DAVID STARR JORDAN
HIGH SCHOOL
STRUCTURAL STRENGTHENING
AND MODERNIZATION OF
AUDITORIUM AND BOILER HOUSE
2245 E. 103rd ST., LOS ANGELES, CAL.
STATE OF CALIFORNIA - DEPARTMENT OF GENERAL SERVICES
AS RE-DESIGNED FOR RECONSTRUCTION
25132 APPROVED NOV 20 1964

INDEX OF SHEETS, SCHEDULE AND MOSAIC PANEL DETAILS

DAVID STARR JORDAN
 HIGH SCHOOL
 STRUCTURAL STRENGTHENING
 AND MODERNIZATION OF
 AUDITORIUM AND BOILER HOUSE
 2265 E. 103RD ST., LOS ANGELES, CAL.
 STATE OF CALIFORNIA - DEPARTMENT OF GENERAL SERVICES
 DIVISION OF ARCHITECTURE AND CONSTRUCTION
 AS REVISED APR 13 1965
 25132 APPROVED NOV 20 1964
 APPLICATION NO. 100
 PER S. Morgan

ROOF PLAN, SECTION AND DETAILS

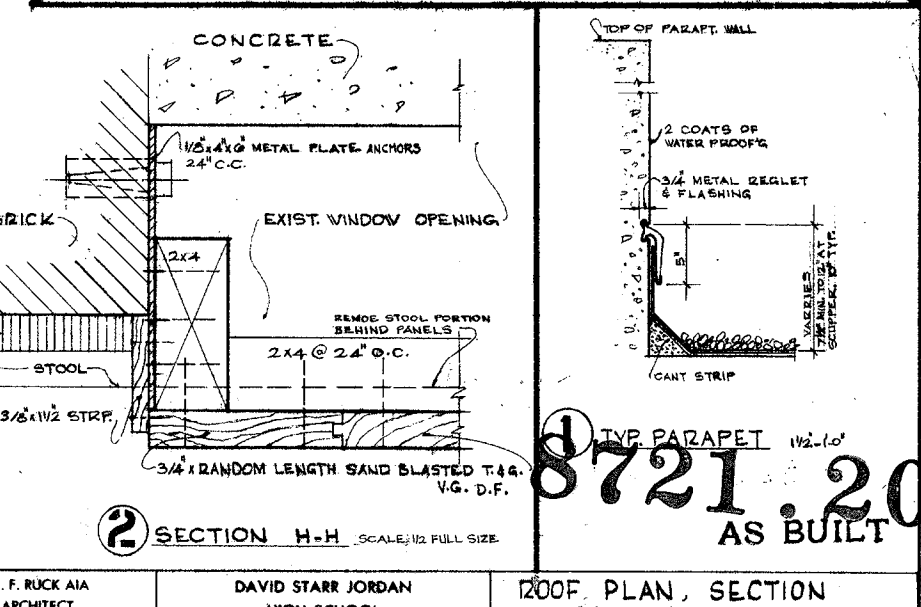
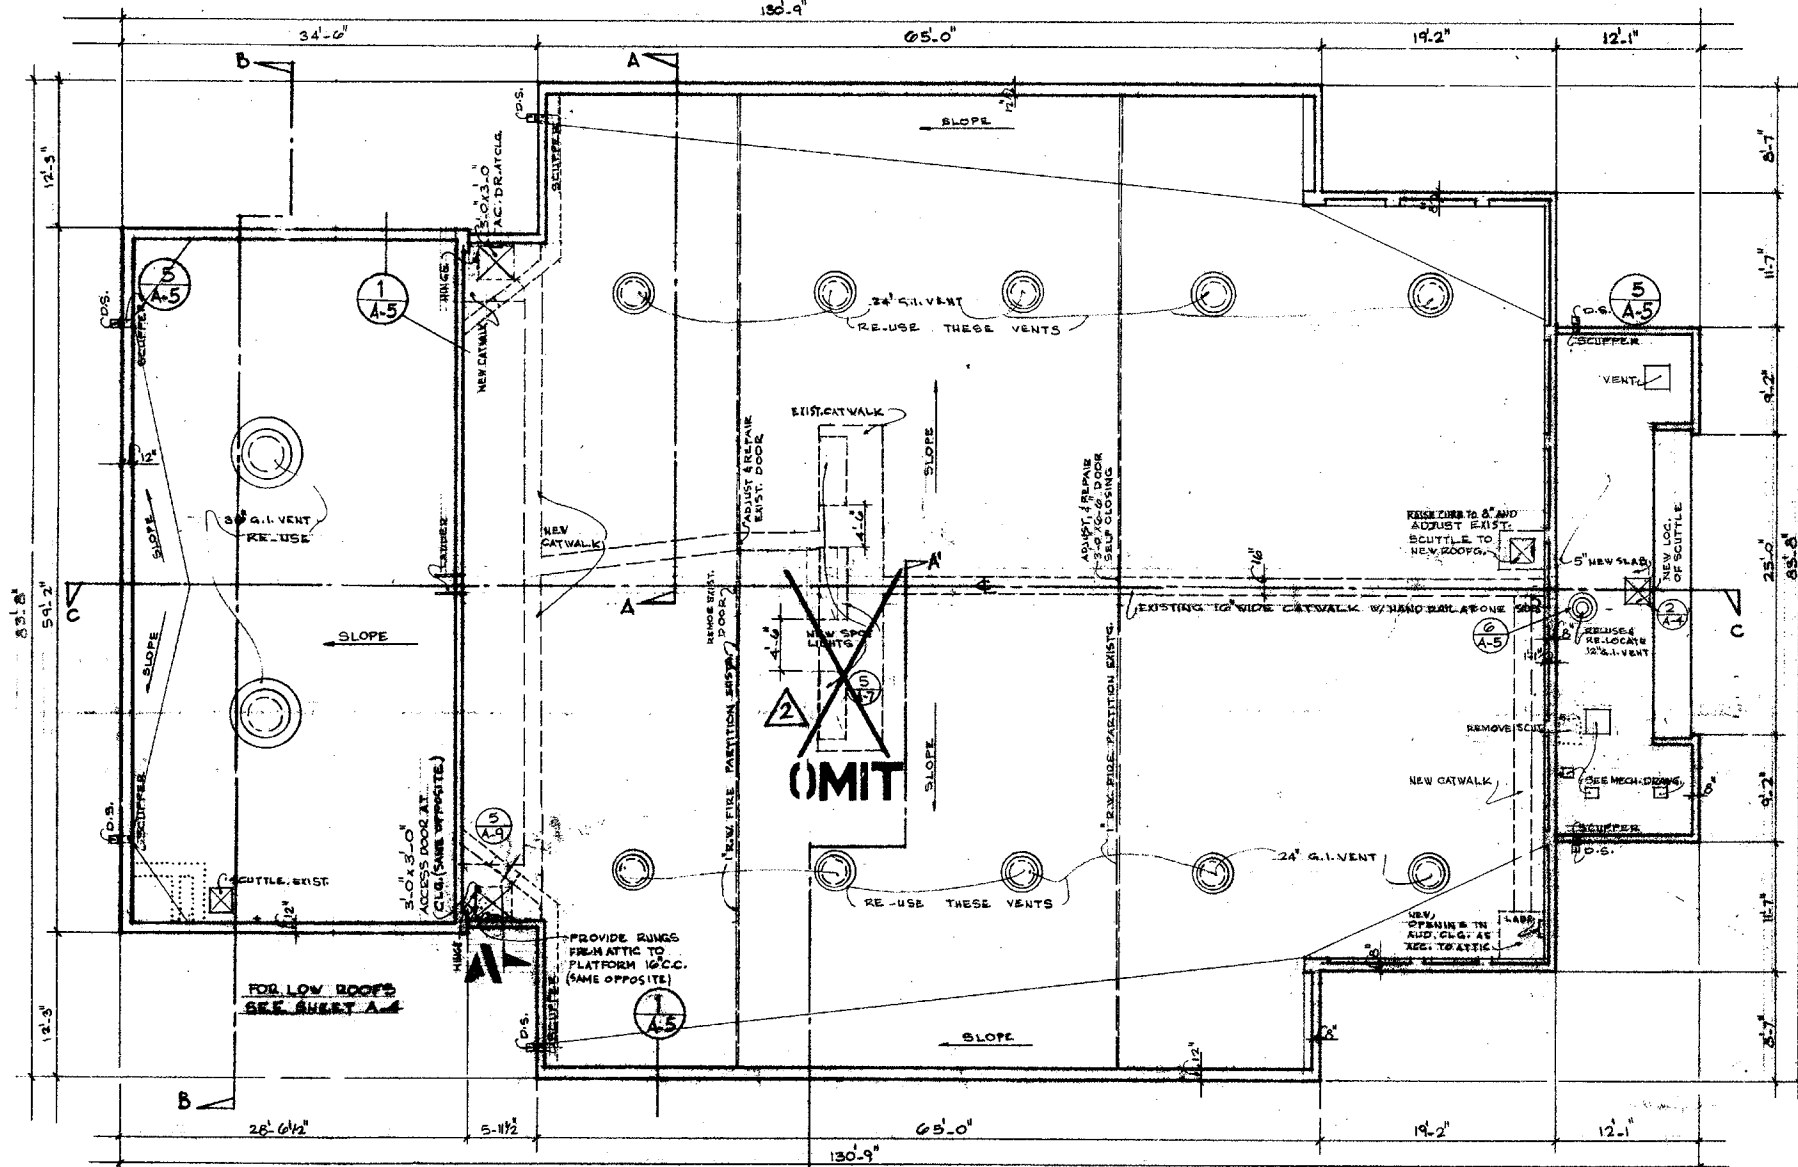
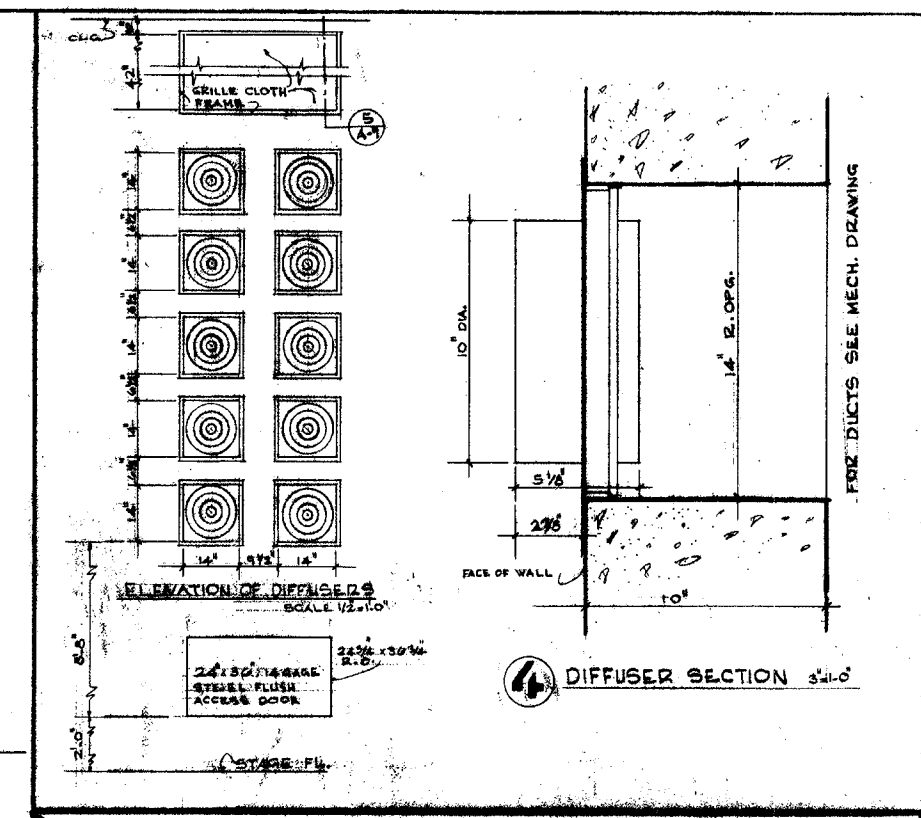
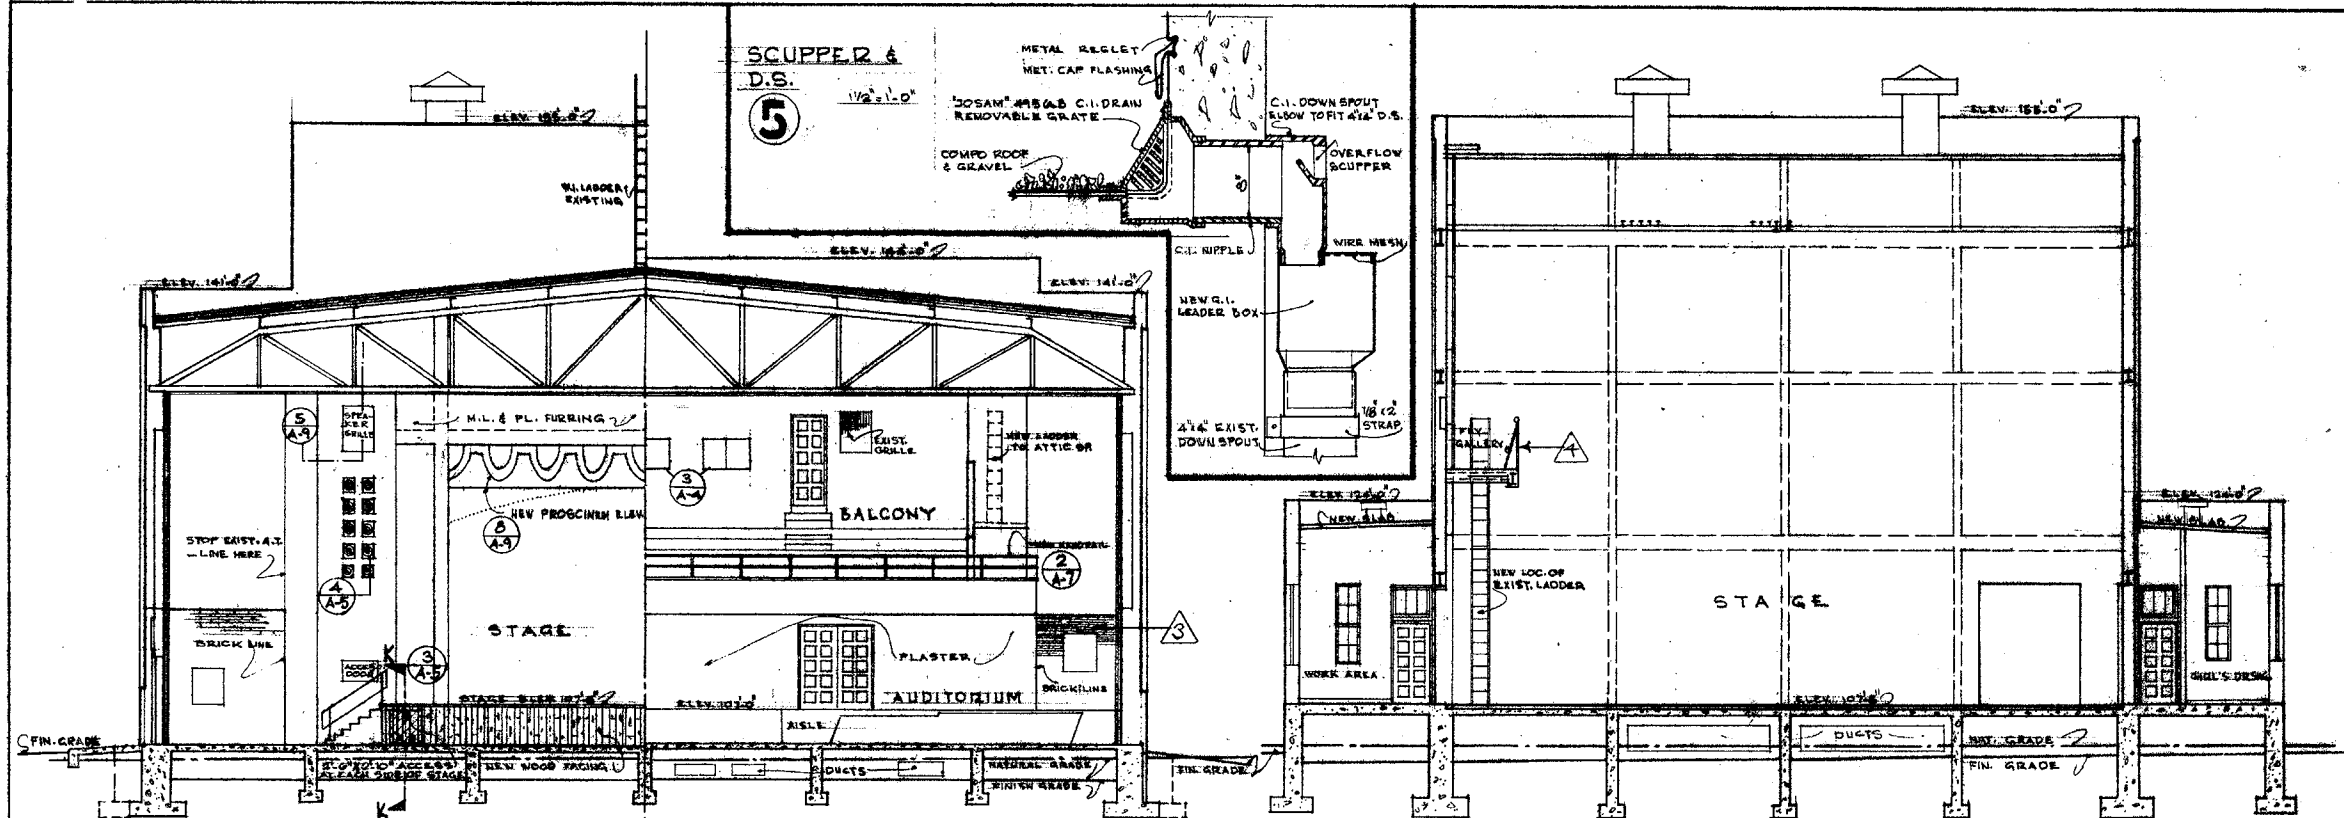
3 CHANGE ORDER T-513 - Provide plaster on area shown as brick

4 CHANGE ORDER T-517 - Remove pin rail

OMIT DET. NO. 3
LEAVE EXIST. SPOT LIGHTS & THEIR ACCESS CATWALK

| W. F. BUCK AIA ARCHITECT 940 S. FIGUEROA ST. LOS ANGELES 15, CAL. | DAVID STARR JORDAN HIGH SCHOOL STRUCTURAL STRENGTHENING AND MODERNIZATION OF AUDITORIUM AND BOILER HOUSE 2265 E. 103rd ST., LOS ANGELES, CAL. | DETAILS | |

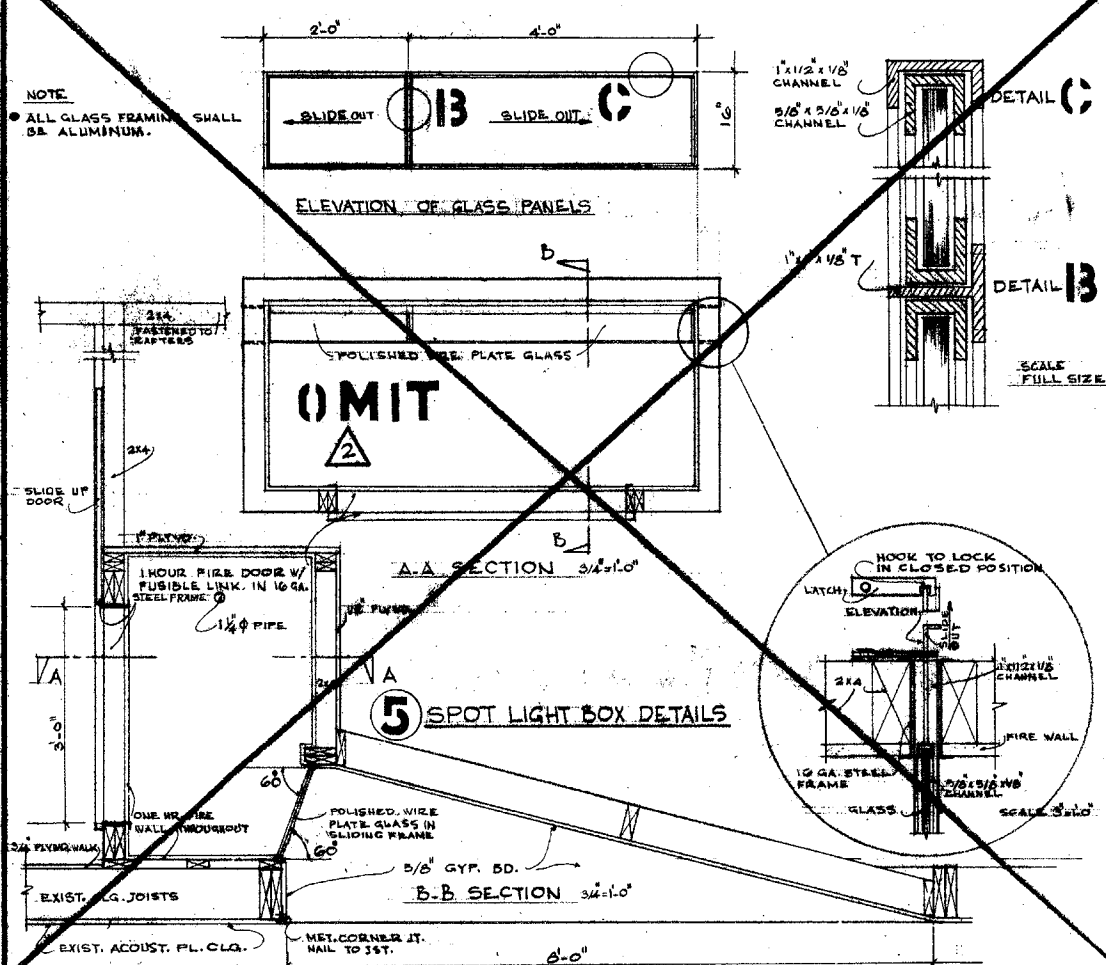
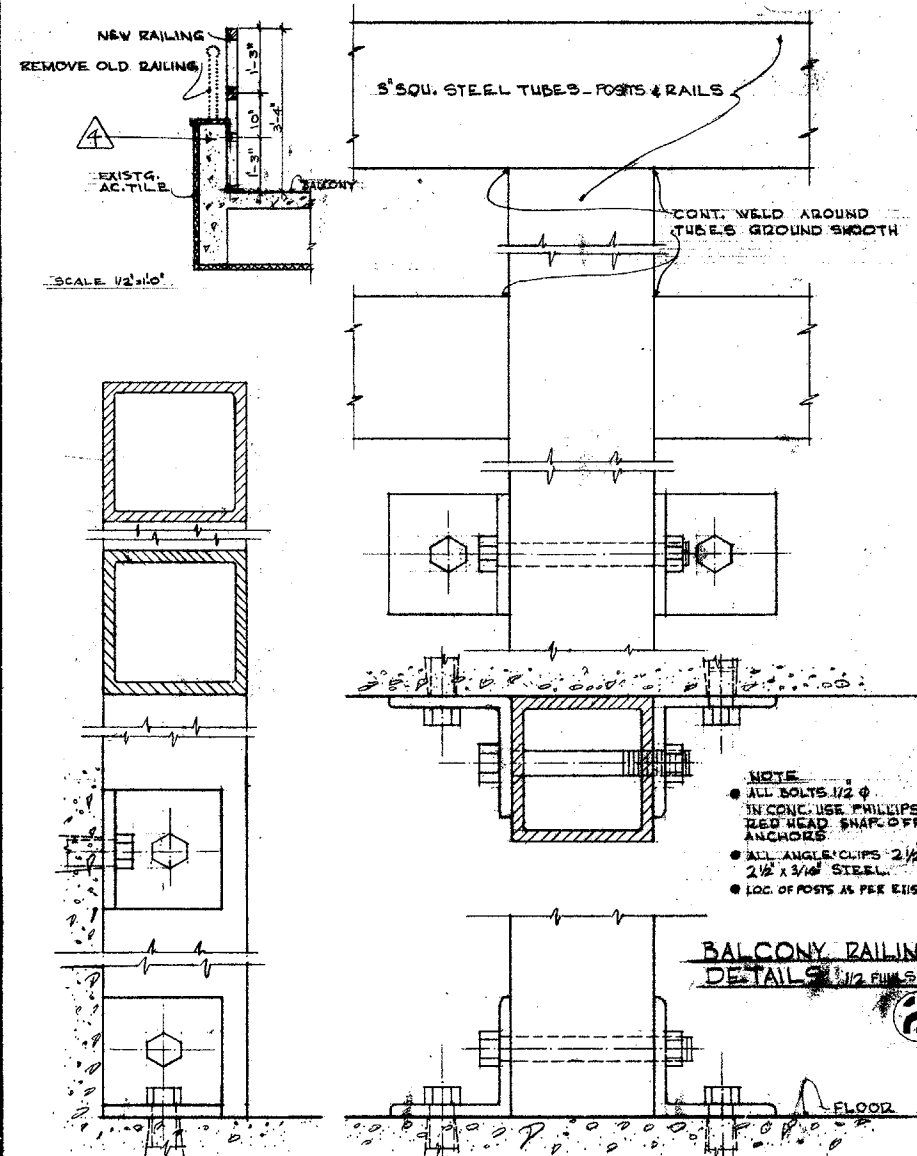
- ① OMIT DETAIL NO. 3
② OMIT DETAIL NO. 5
③ DISREGARD DETAIL NO. 6

DETAILS
NORMAN B. GREEN
STRUCTURAL ENGINEER
548 S. SPRING ST., LOS ANGELES, CAL.
REC. NO. 115 Norman B. Green
PREPARED FOR THE
BOARD OF EDUCATION
LOS ANGELES UNIFIED SCHOOL DISTRICT
DATE 11/28/64
BY N.B.G.
SHEET 1.9

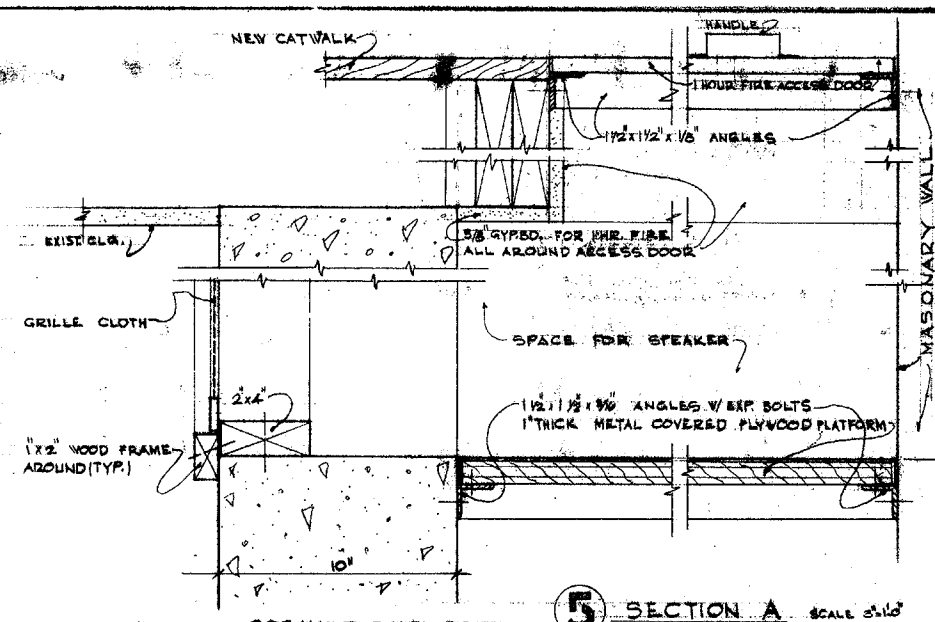
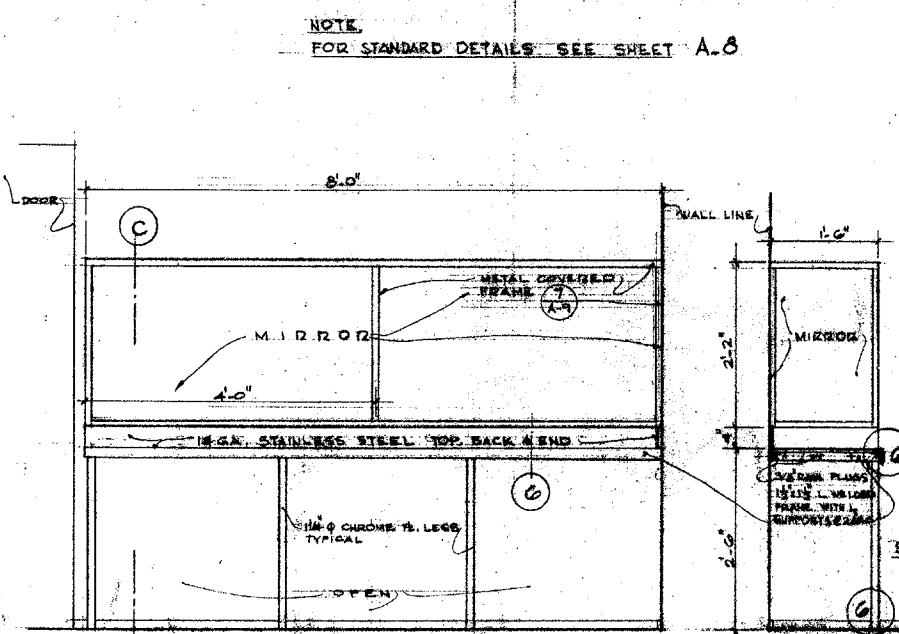
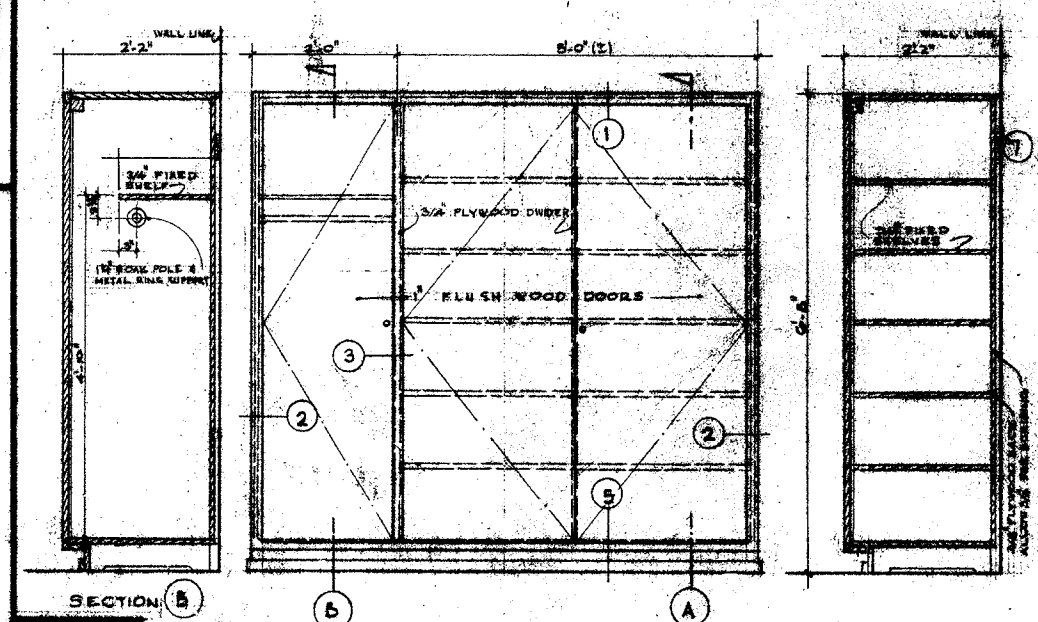
ADDENDUM NO. 2
NEW DETAIL & PATTERN

CHANGE ORDER T-511 - New plaster on face of existing conc.
